FEDERAL AID PROJECT
PROJECT NO.
CSJ: 0610-03-095
**TITUS COUNTY
IH 30**

FOR WORK CONSISTING OF CONSTRUCTING WEIGH STATION AND RAMPS

60% PLANS

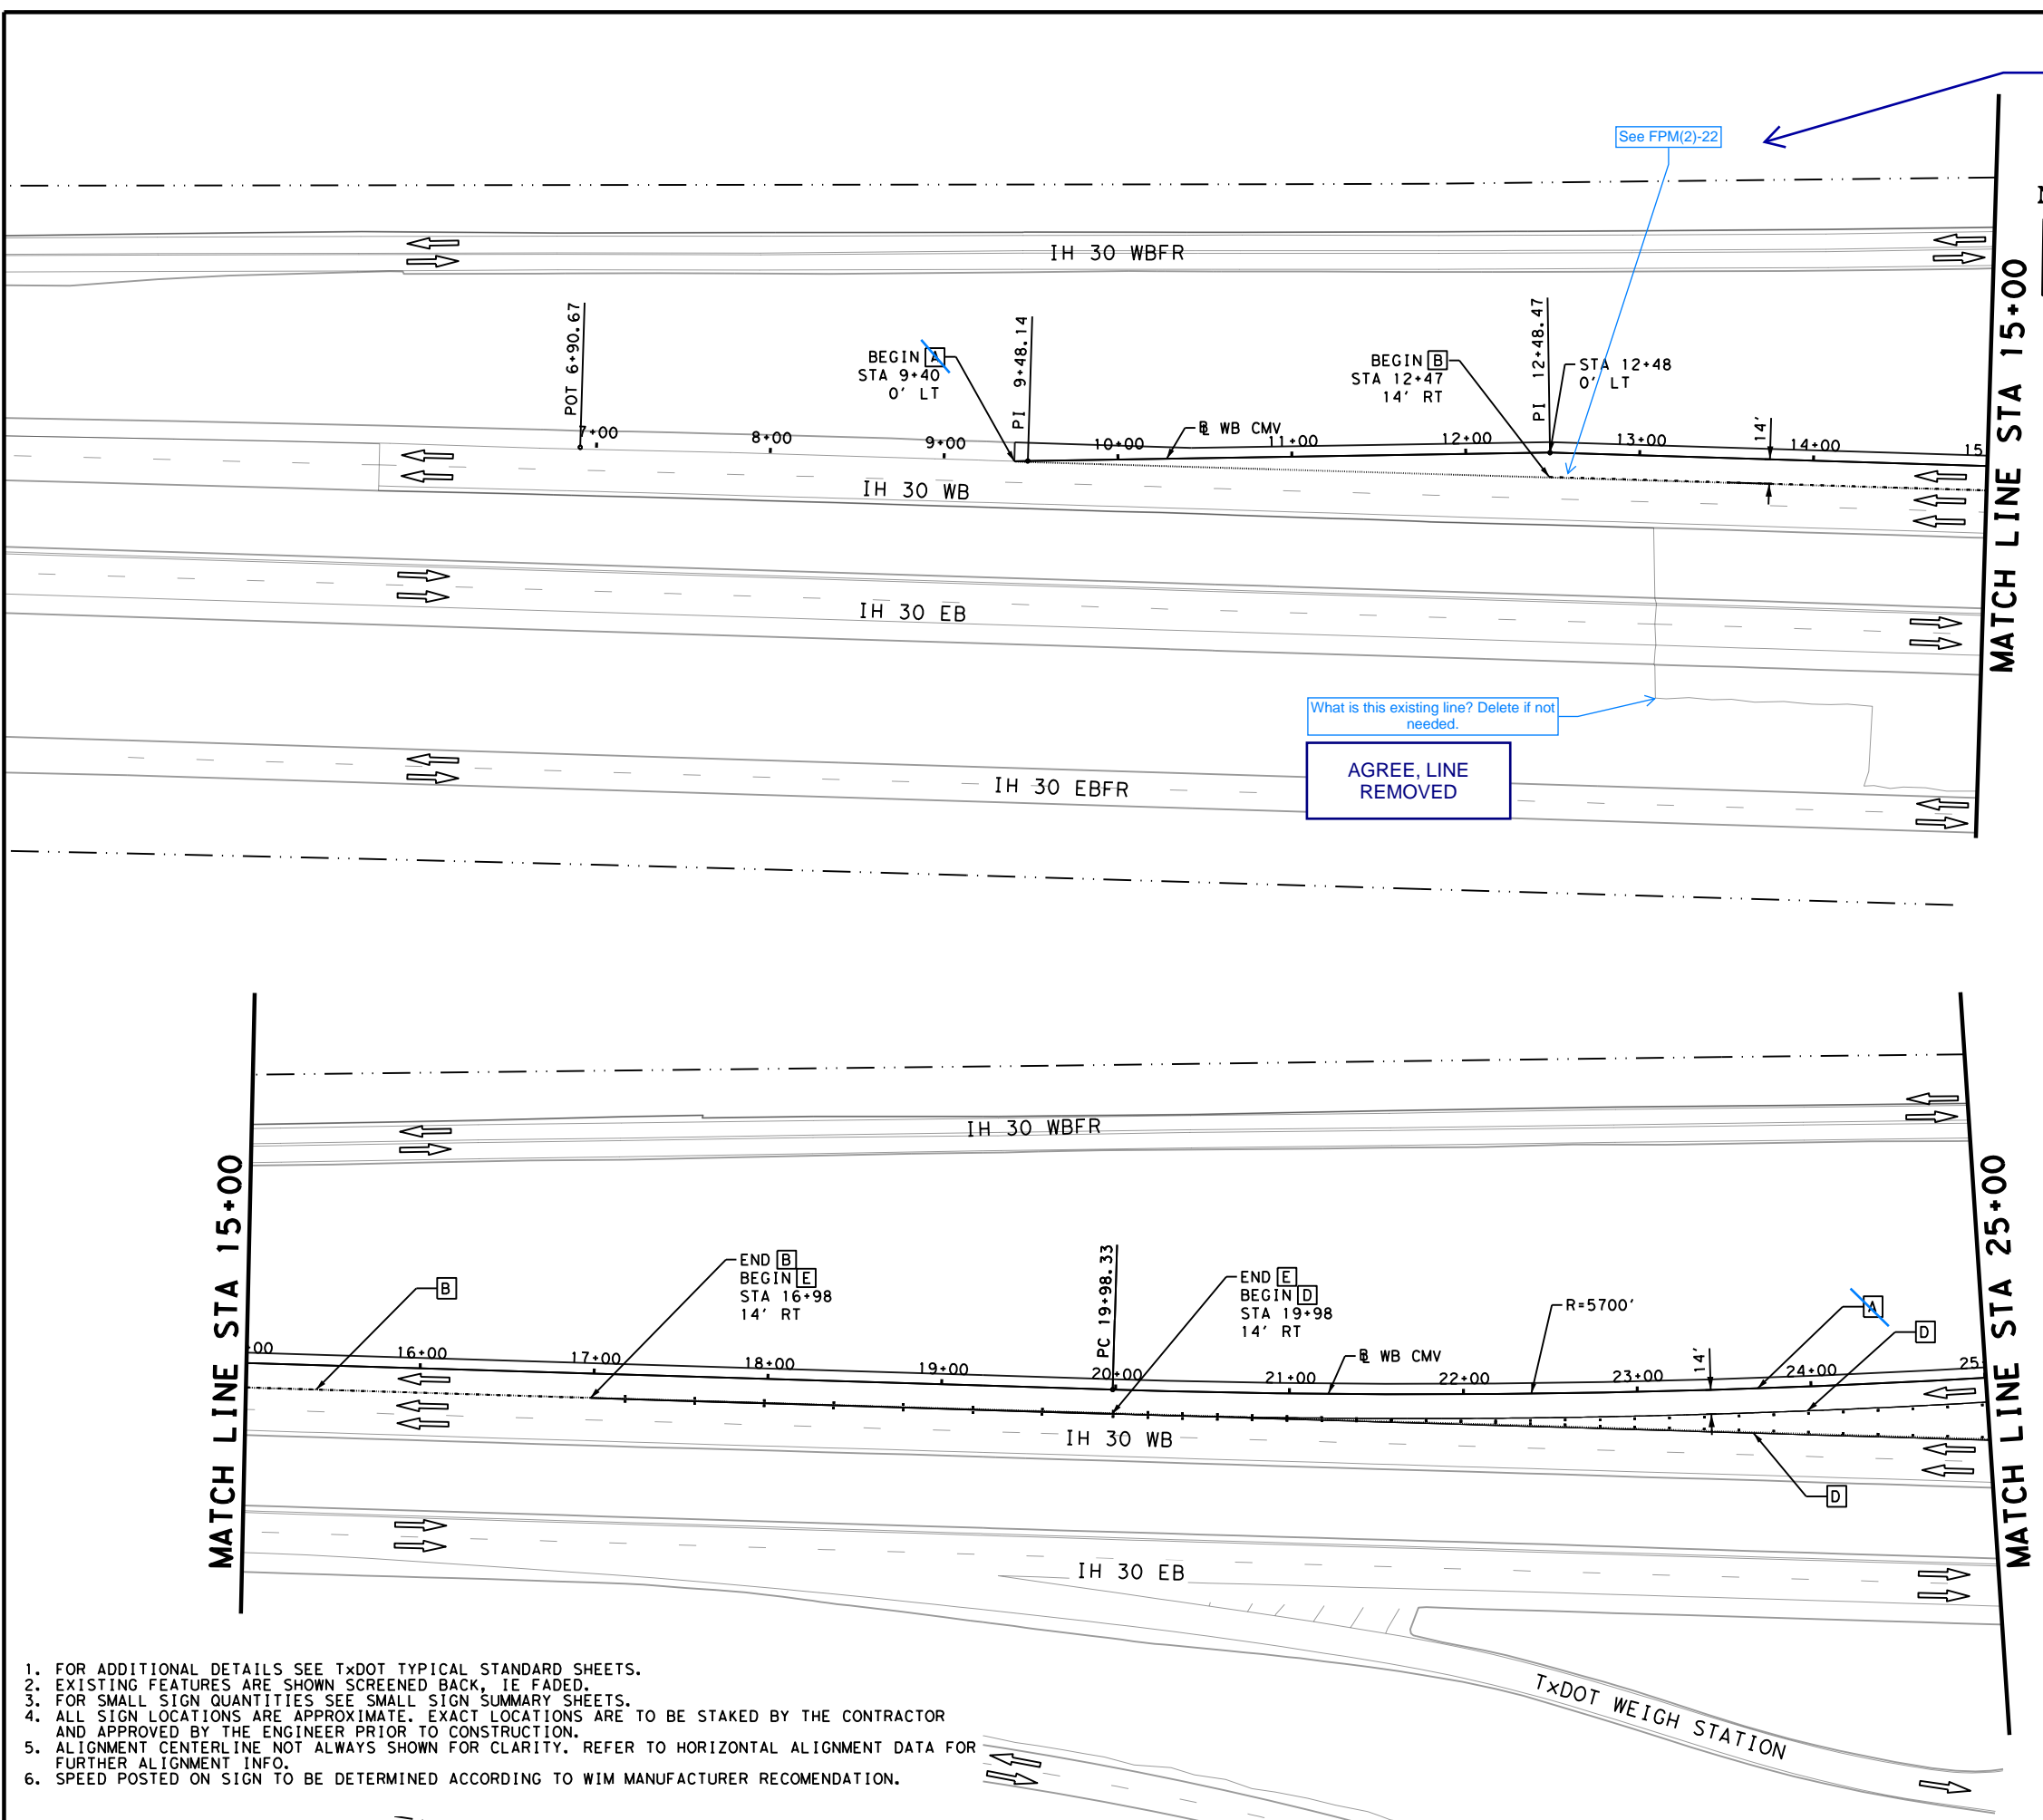
Correct Legend with new bid items; See Summary of Quantities Sheet 13

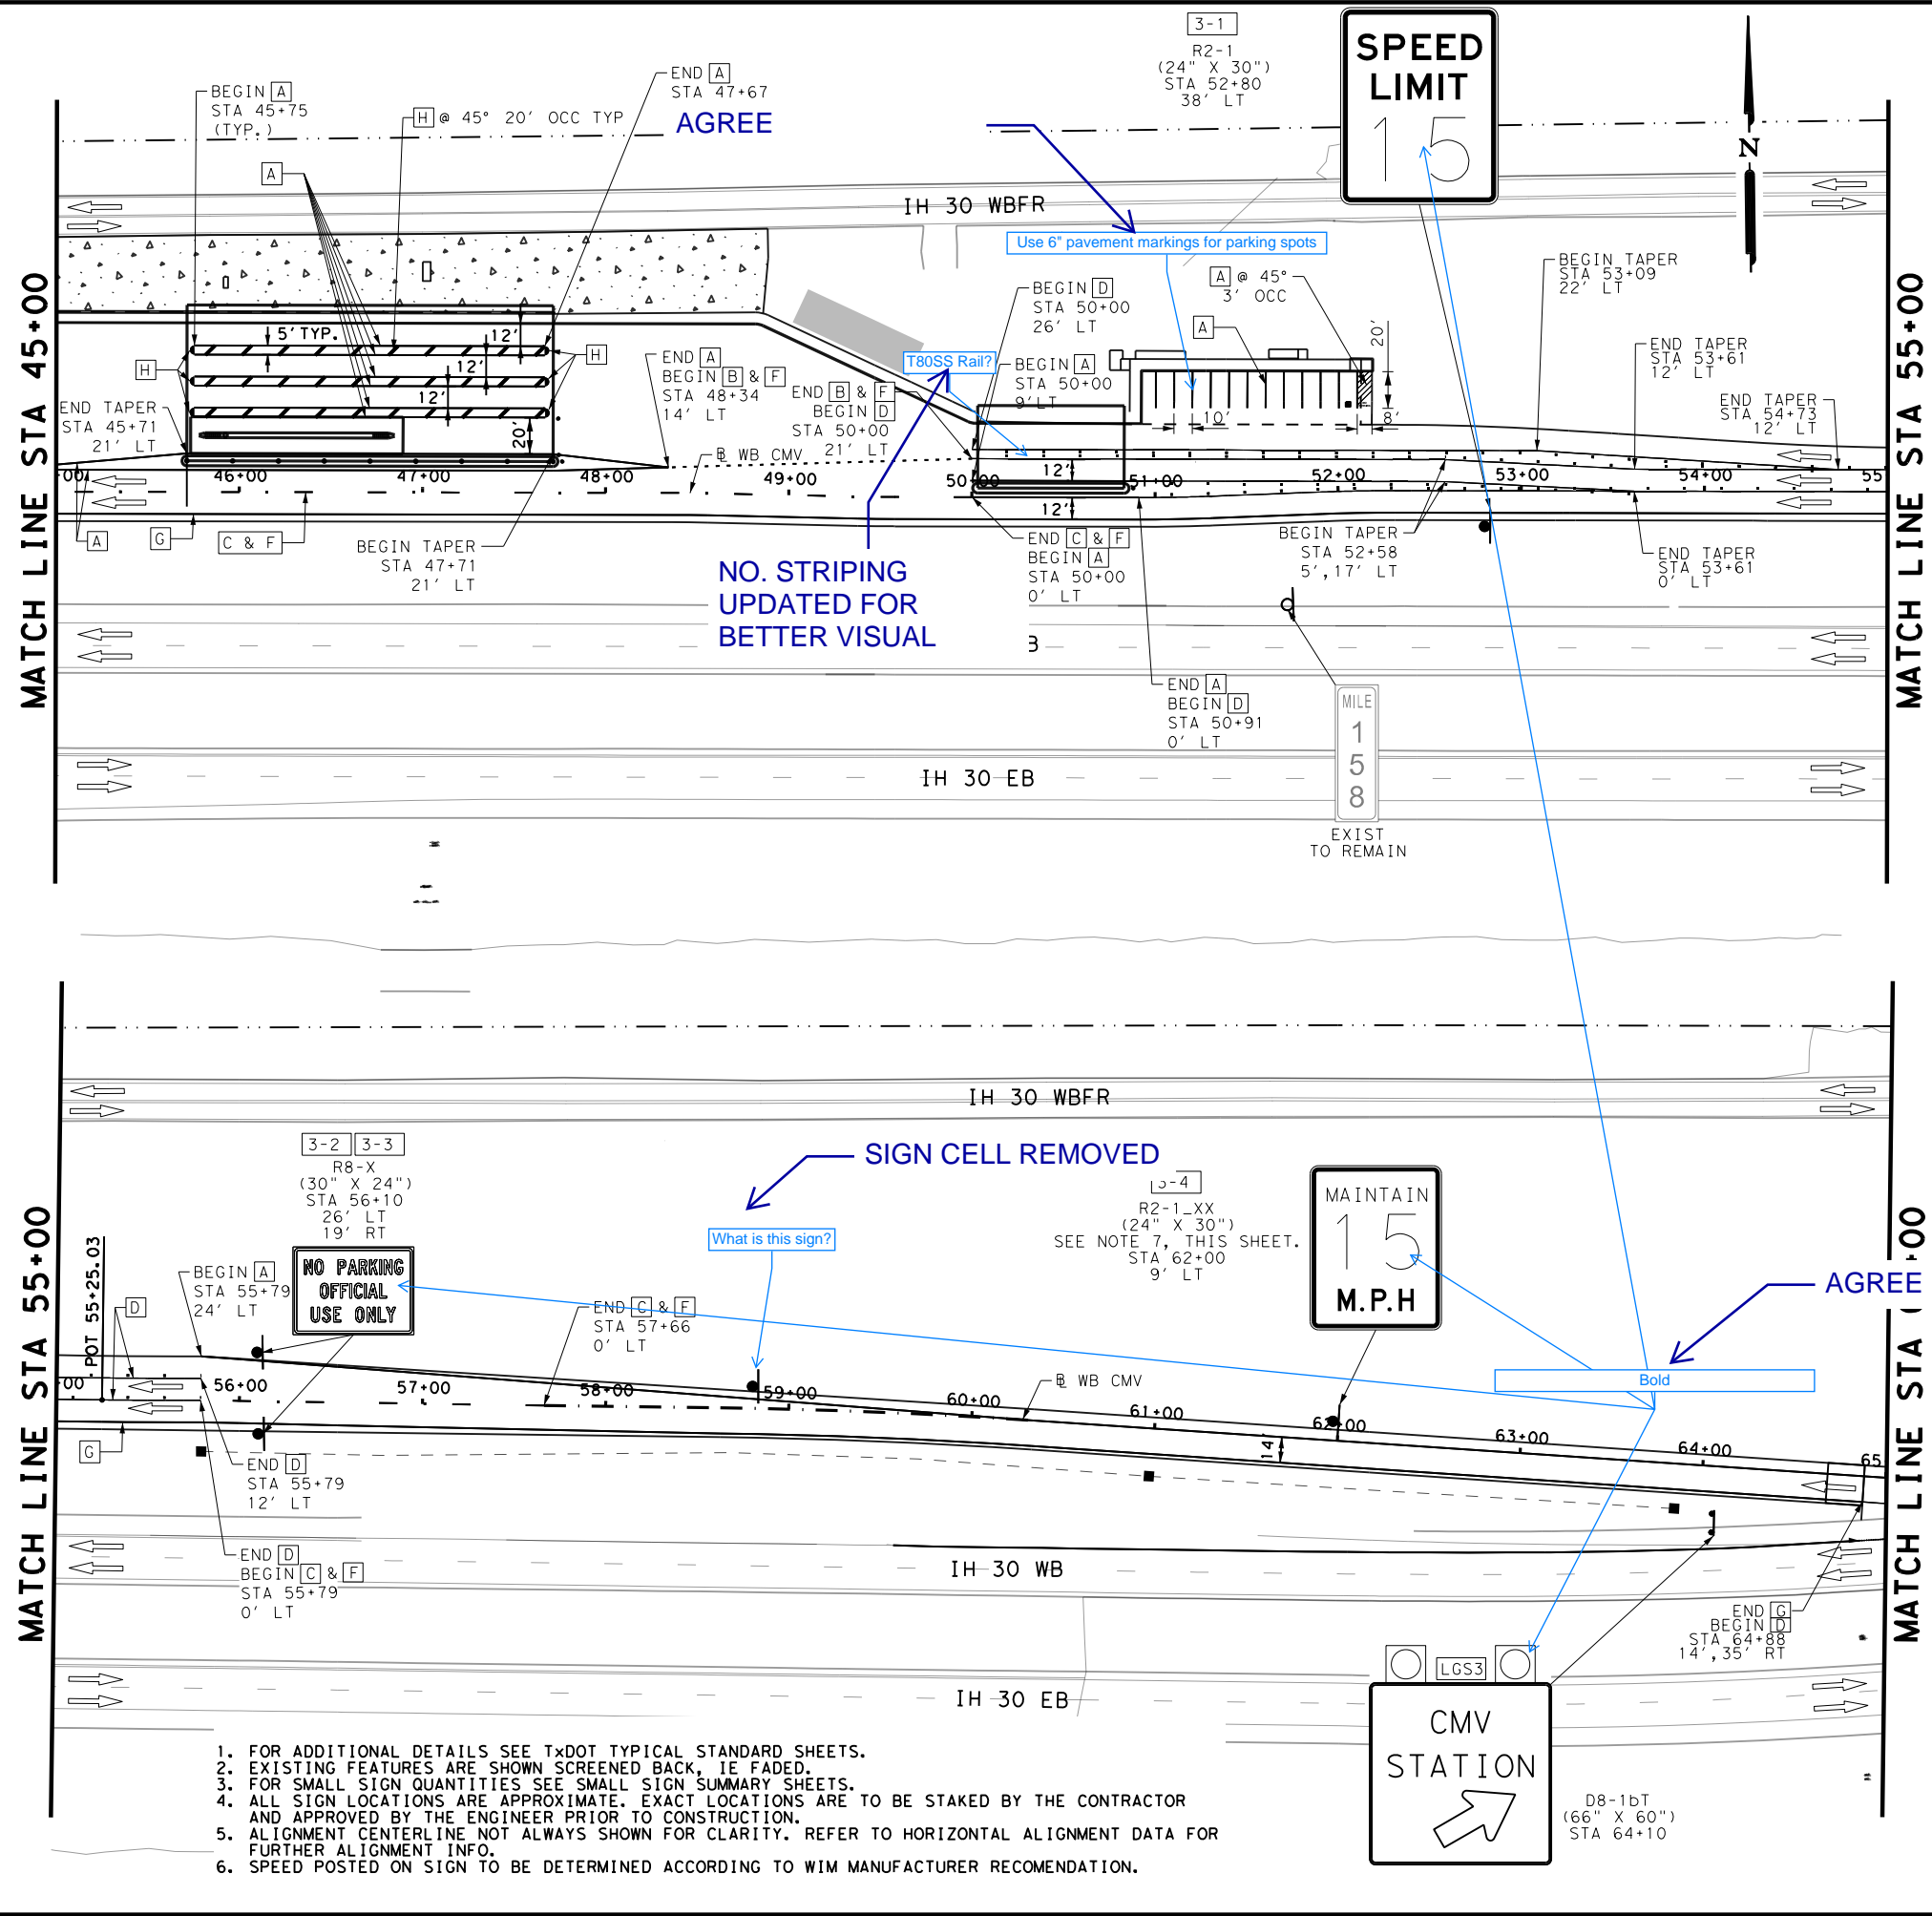
NOTES
 1.) BOLD ALL ARROWS AND TEXT LIKE SHEETS 141 AND 142.
 2.) ALSO MATCH CORRECTIONS FROM SHEETS 141, 142, AND SUMMARY OF QUANTITIES SHEET 13

WB IH 30 CMV STATION
SIGNING & PAVEMENT MARKINGS PLAN
 STA 65+00 TO END PROJECT
 SHEET 4 OF 4

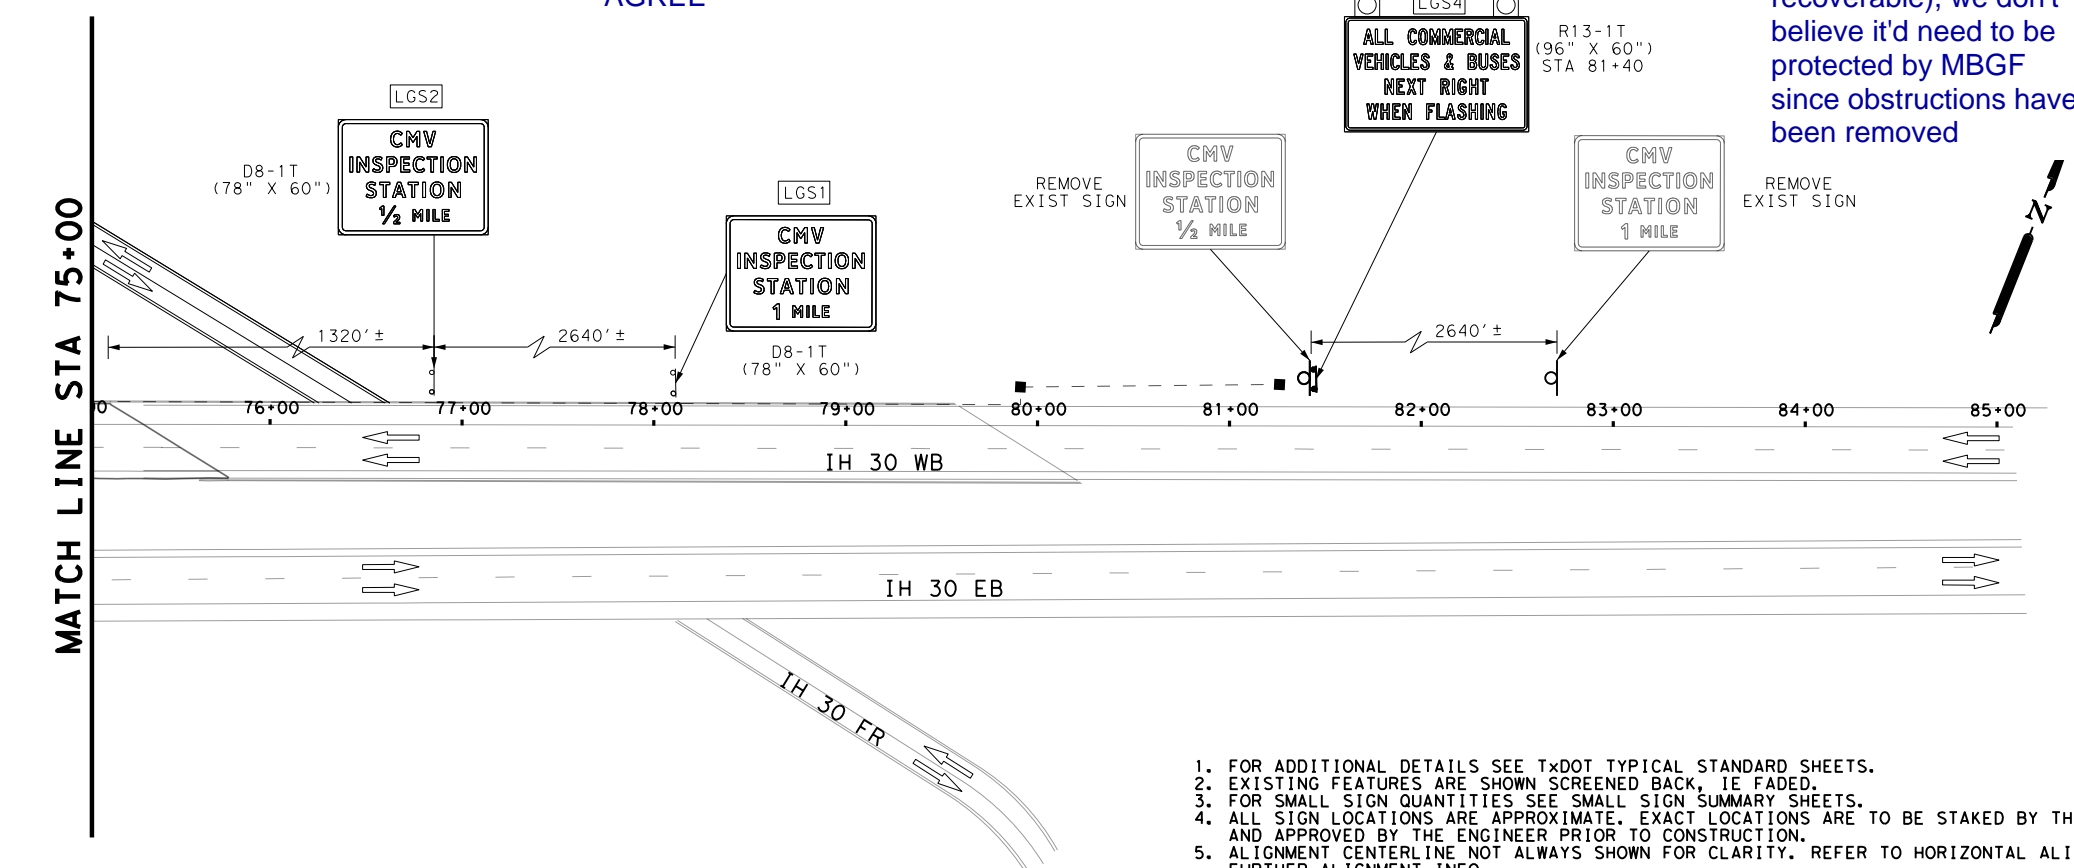
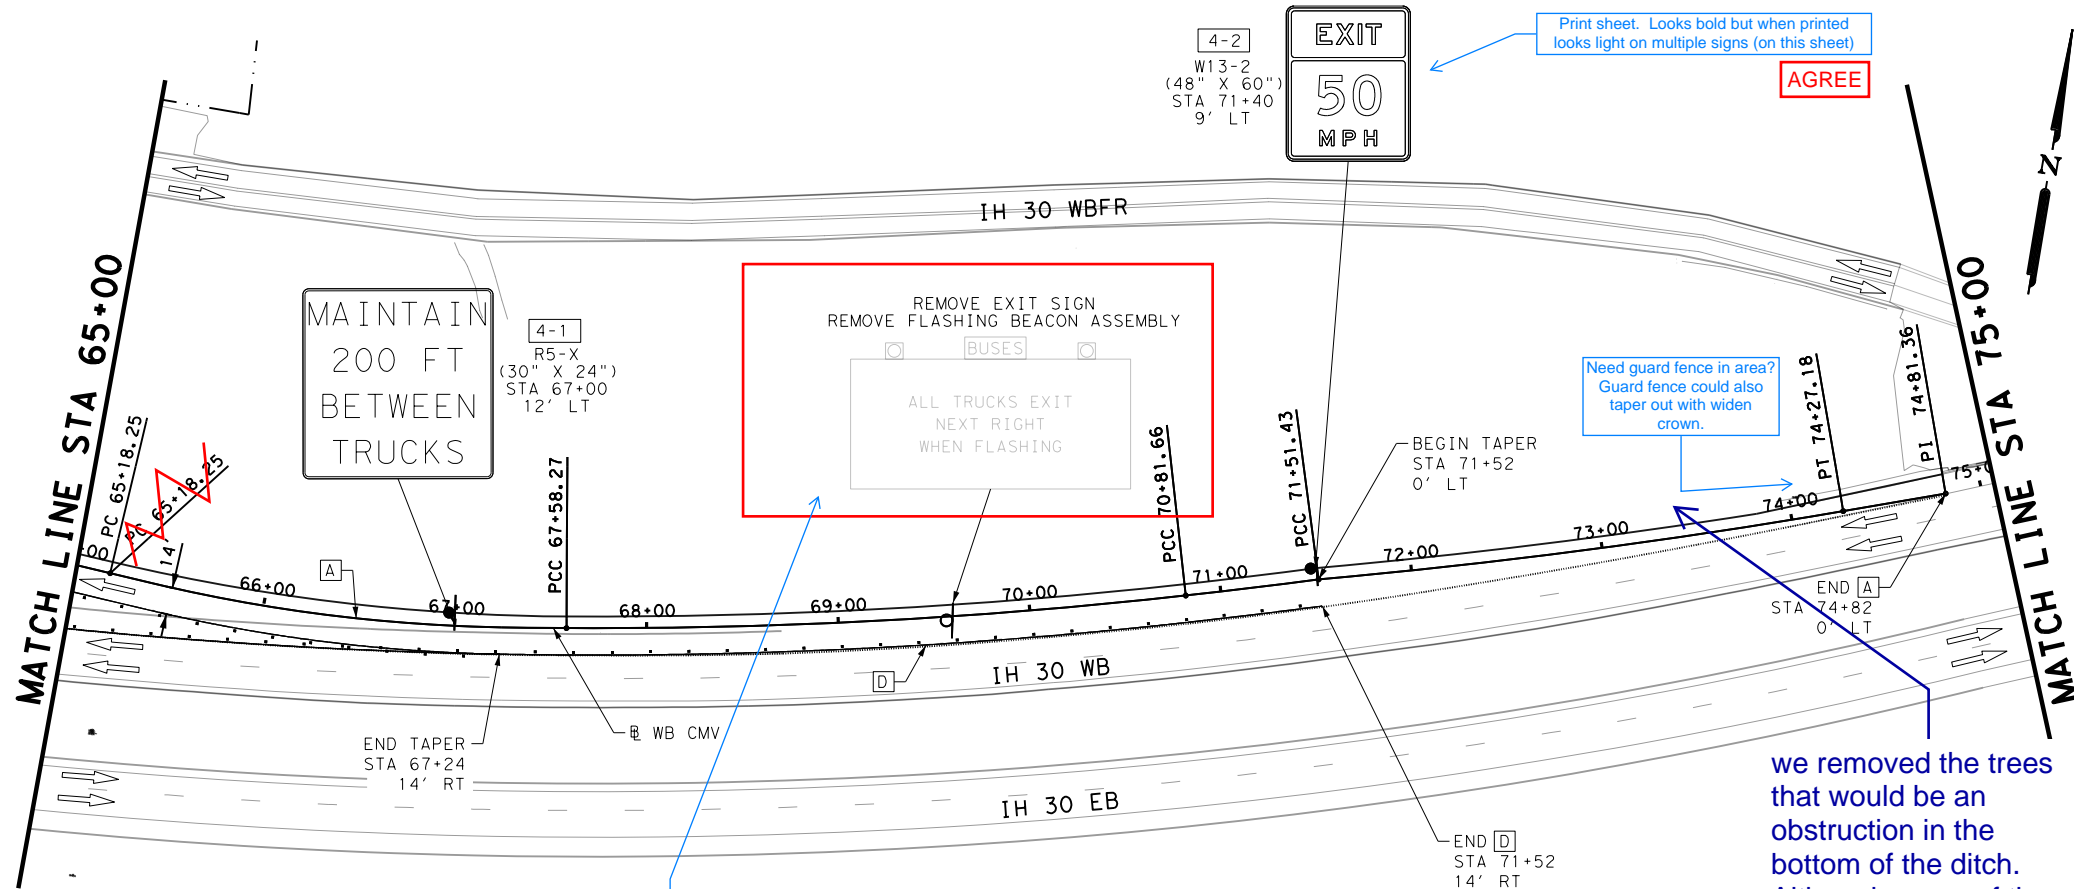
NOTES
 1.) BOLD ALL ARROWS AND TEXT LIKE SHEETS 141 AND 142.
 2.) ALSO MATCH CORRECTIONS FROM SHEETS 141, 142, AND SUMMARY OF QUANTITIES SHEET 13
